**Addendum No. 1
to the Bidding Documents for**

BID PROPOSAL #09-15

**Hobbs Hill Water Tank Replacement
City of Portsmouth Department of Public Works
Portsmouth, New Hampshire**

Issued September 8, 2014

0.6 MG TANK ELEVATION
 AND SECTION

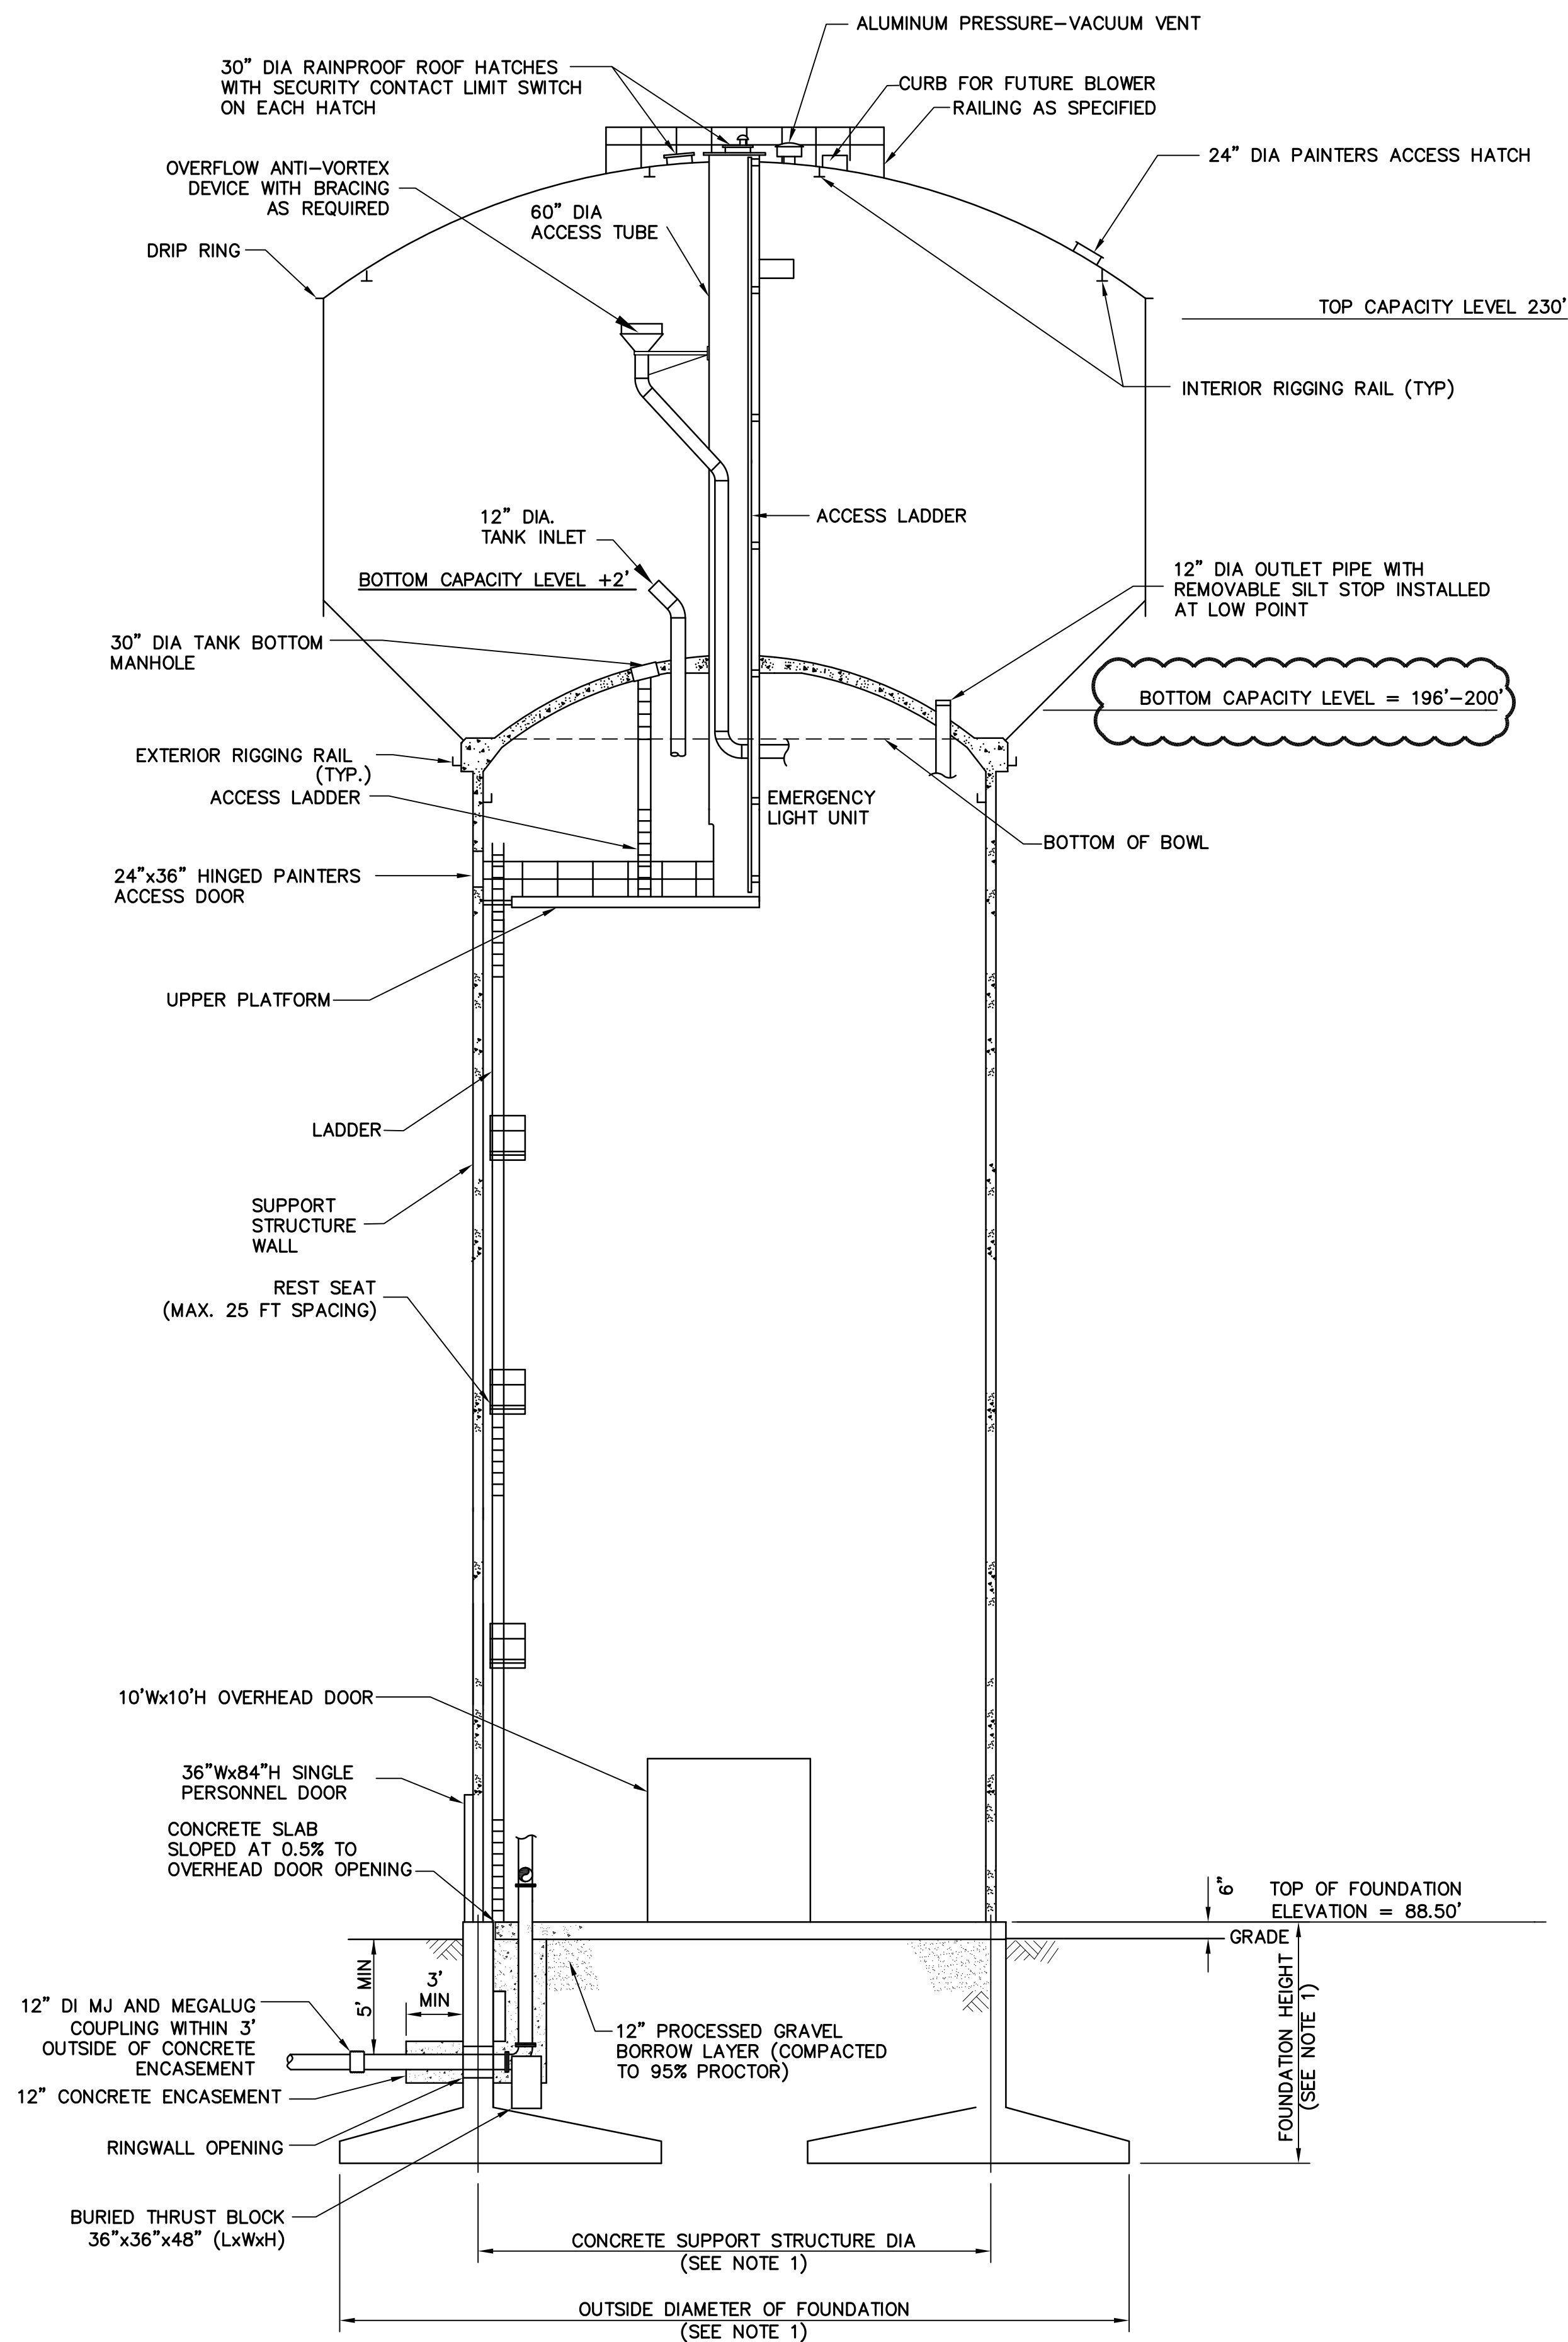
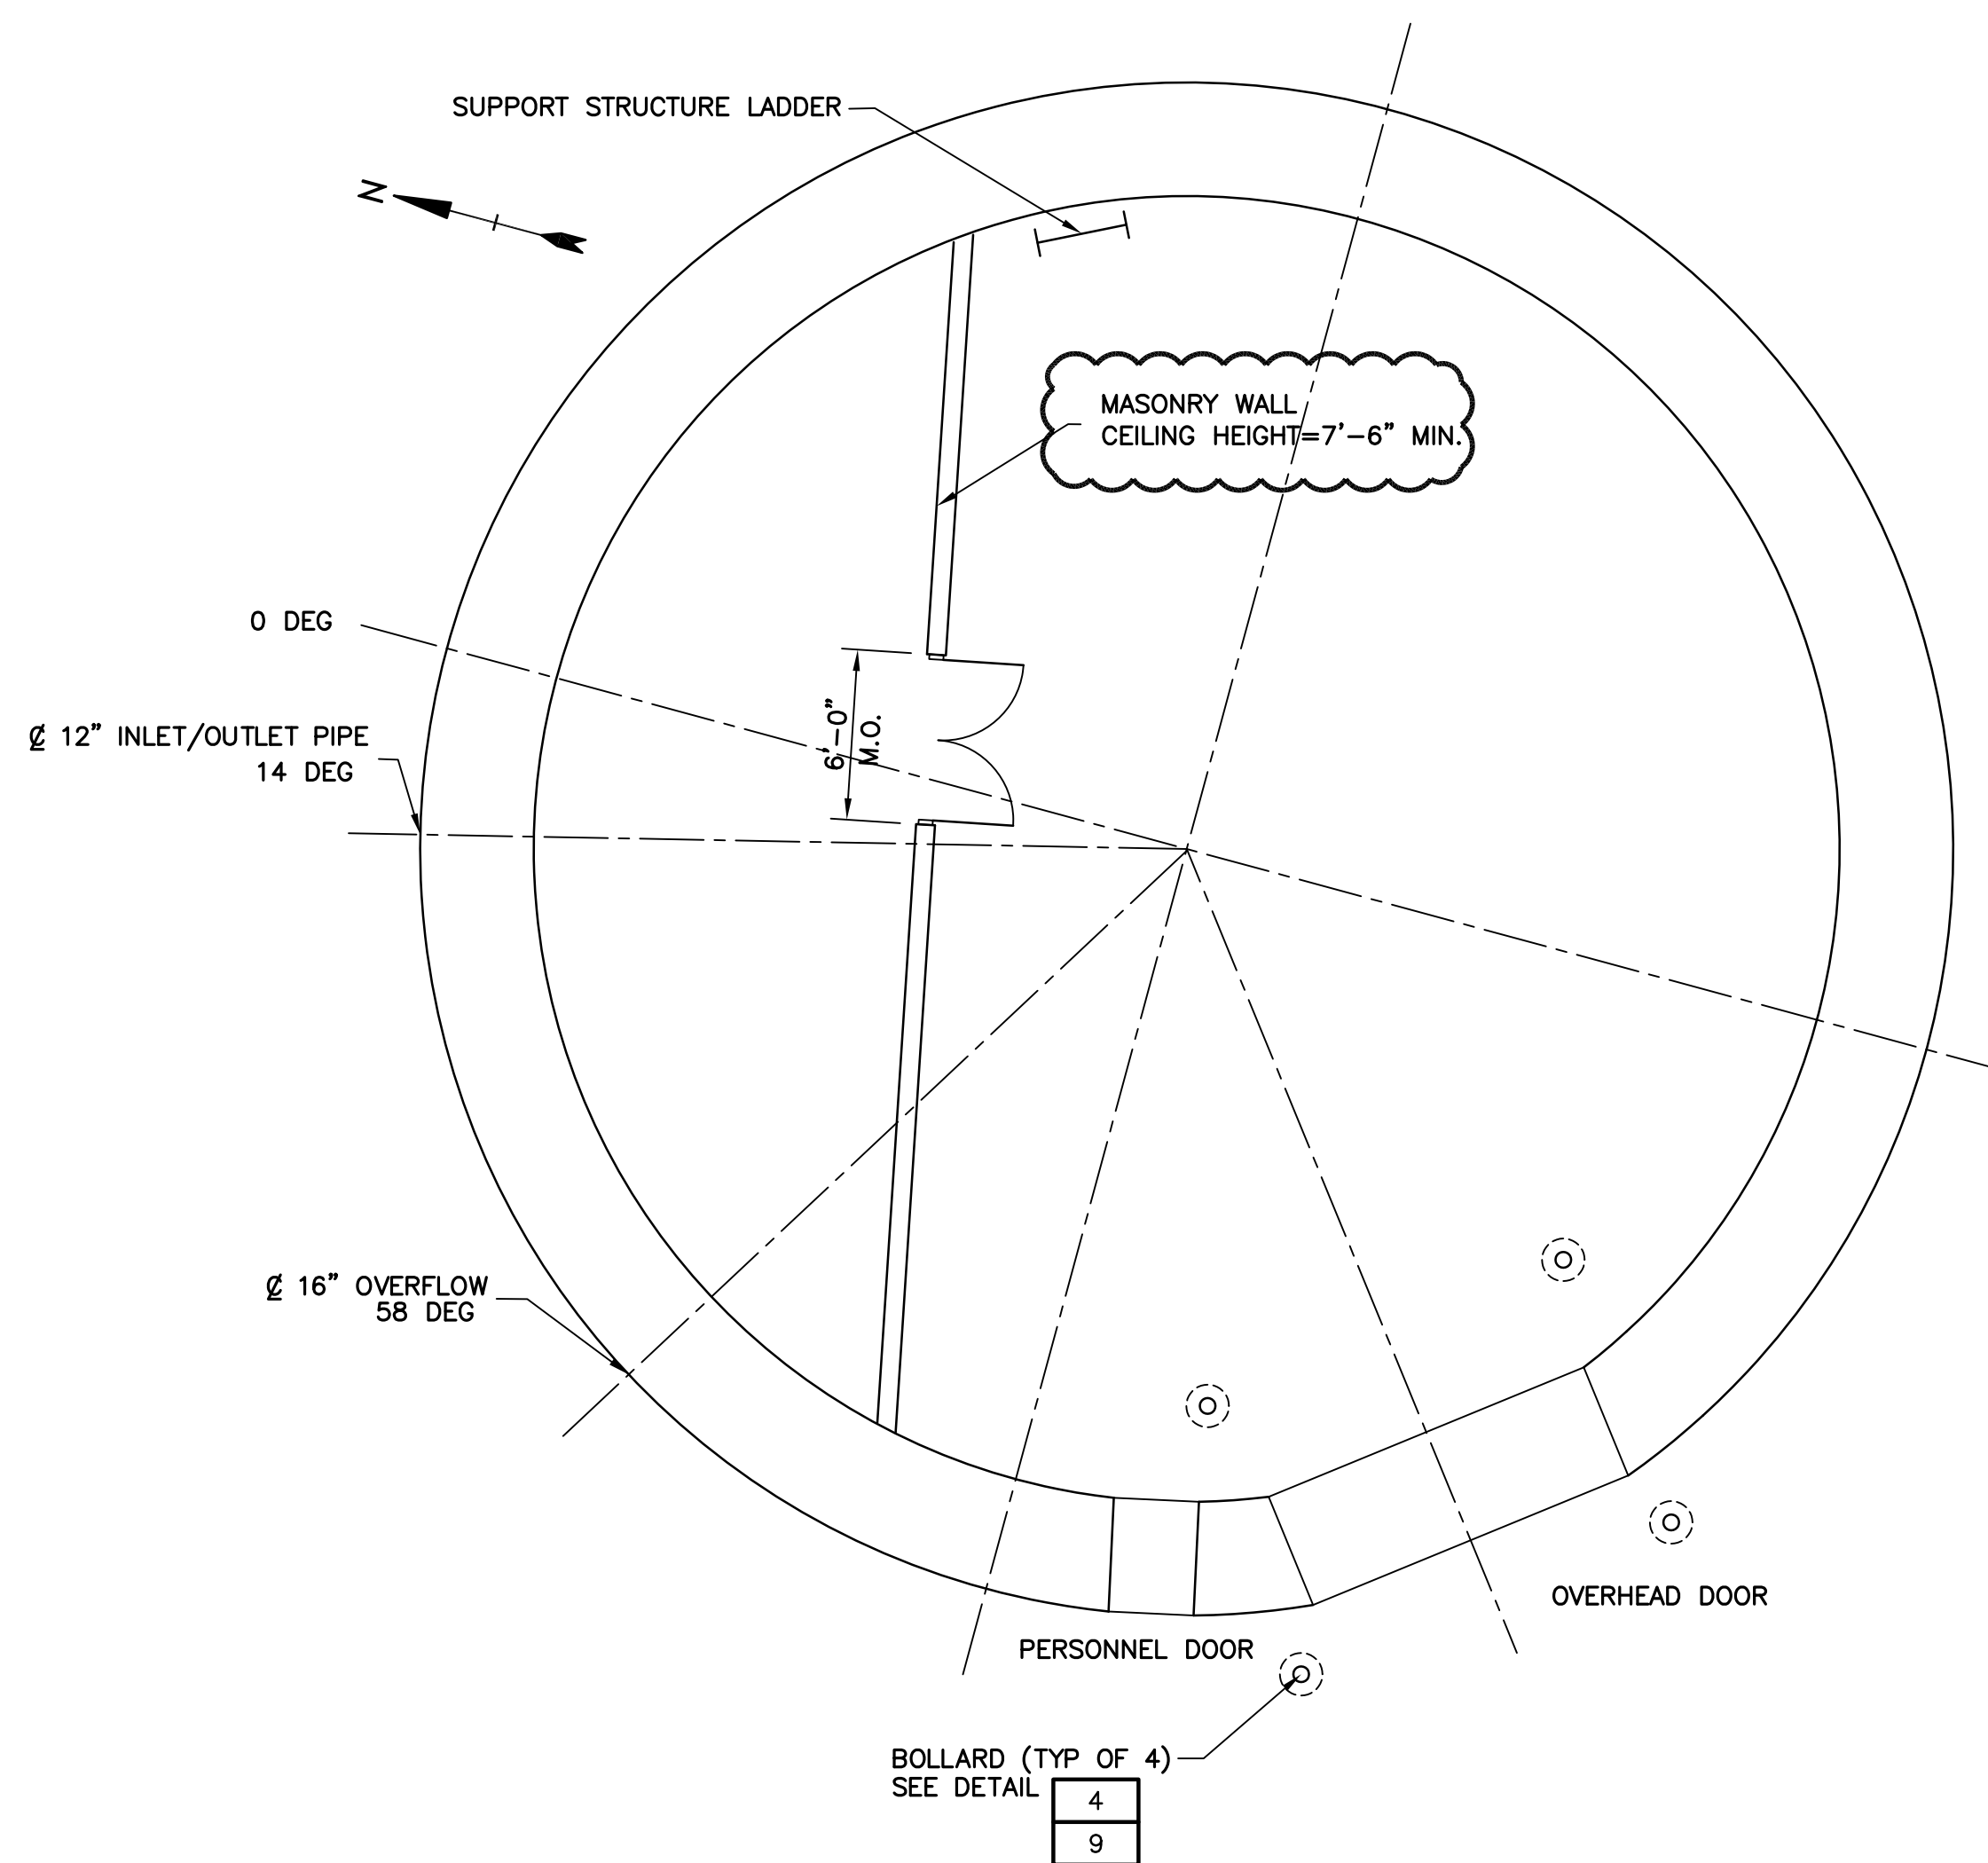
5. Can we use our standard head range of 33' (Sheet 6, Elevation and Section 13210 1.7 B)?

6. Can the overflow pipe be on the exterior of the access tube (Sheet 6, Elevation)?

The overflow pipe is currently shown as a welded penetration through the side of the 60-inch diameter access tube. The advantage is it eliminates one flanged penetration through the concrete tank bottom, which T&B believes is a greater long term maintenance issue as compare to the fabricated penetration through the access tube. An alternative configuration consisting of an overflow pipe internal to the steel tank (exterior of the access tube) and penetrating through the concrete tank

7. Can we use our galvanized rest platforms in lieu of aluminum rest seats (Sheet 6, Elevation and Section 13210 2.5 D.1)?

31. Page 13210-14 specifies a 10'x10' overhead door as does drawing sheet 6. Drawing sheet 10 specifies a 12'x12' overhead door. Please clarify door size.

32. Drawing sheet 6 shows overflow piping going through access tube. Our typical overflow pipe does not go through the access tube. Please clarify that this is acceptable.

44. The Masonry wall inside the pedestal of the tank shown on sheet 6 has no height associated with it. Please provide.

54. Sheet 6 shows the incoming waterline passing over the foundation. Our design will incorporate the incoming waterline into the foundation. Please confirm this is acceptable and we are not required to place the foundation deeper than required by our design to allow the waterline to pass over the foundation.

The following alternative Operating Parameters as described Section 13210 1.7 B will be acceptable:

Operating range (min. - max.)	25-34 feet
Bottom of Tank Bowl Elevation	196 feet minimum

bottom would be acceptable, conditional upon approved shop drawings, if it is demonstrated that it addresses the long term maintenance concerns.

Yes - galvanized rest platforms can be used in lieu of aluminum rest seats.

The overhead door size shall be 10 feet by 10 feet.

Refer to response to question #6 above.

Ceiling height shall be not less than 7'-6".

The proposed foundation the design will need to accommodate the incoming waterline configuration and these details are to be addressed as part of the shop drawing review/approval process.
